July 27, 1981

The enclosed paper will be presented and submitted for record at the July 29, 1981 public hearings on the San Onofre Nuclear Generating Station licensing of units two and three to be held at San Clemente High School.

THE VULNERABILITY OF  
THE SAN ONOFRE NUCLEAR GENERATING STATION TO ACTS OF  
SABOTAGE AND TERRORISM

Fig. 1. Unit 1 intake terminal structure.

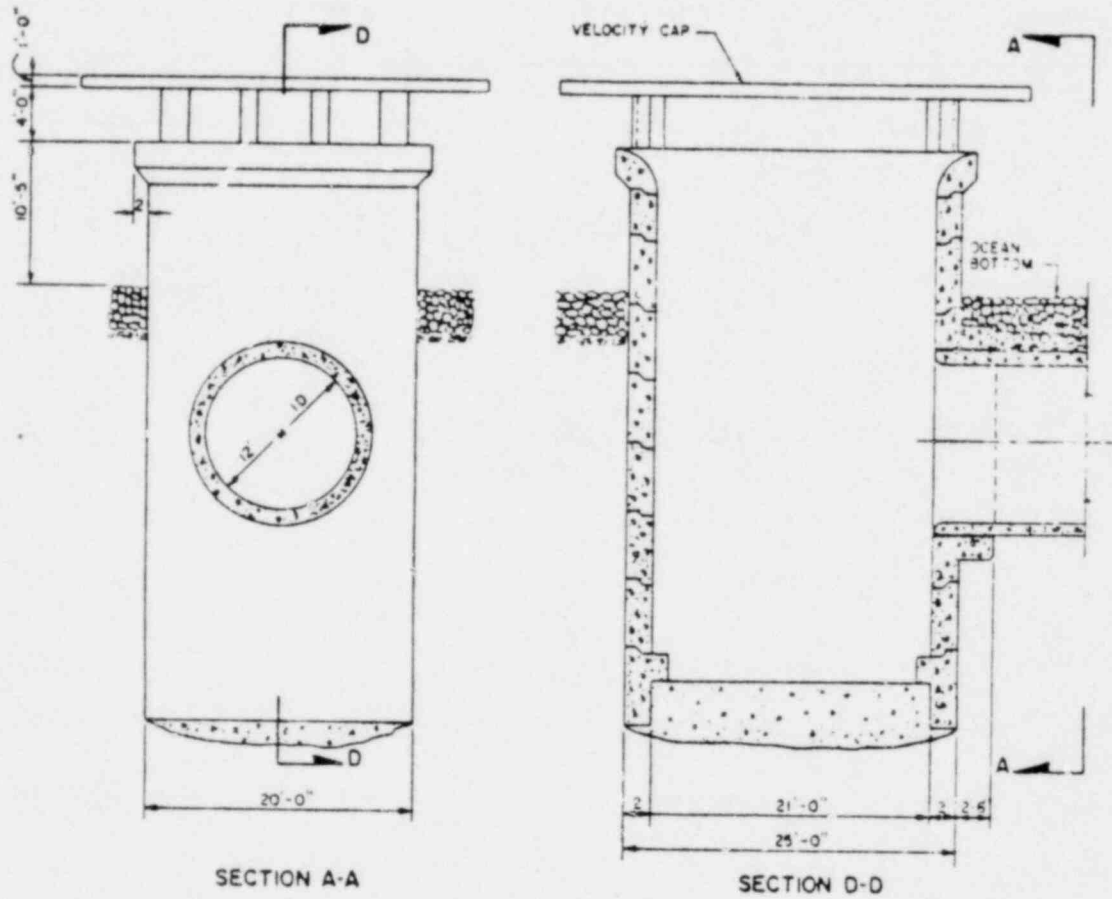
An example of this vulnerability is that a scuba diver can easily swim into the intake structures (fig.1) and 3300 feet through the large pipes (fig.2) and be inside the plant in about eight minutes

place explosives near the pump impellers. Then with the help of a boat and line be pulled out and after some miles away detonate the explosives stopping all cooling waters to the condensers, creating within hours a core meltdown.
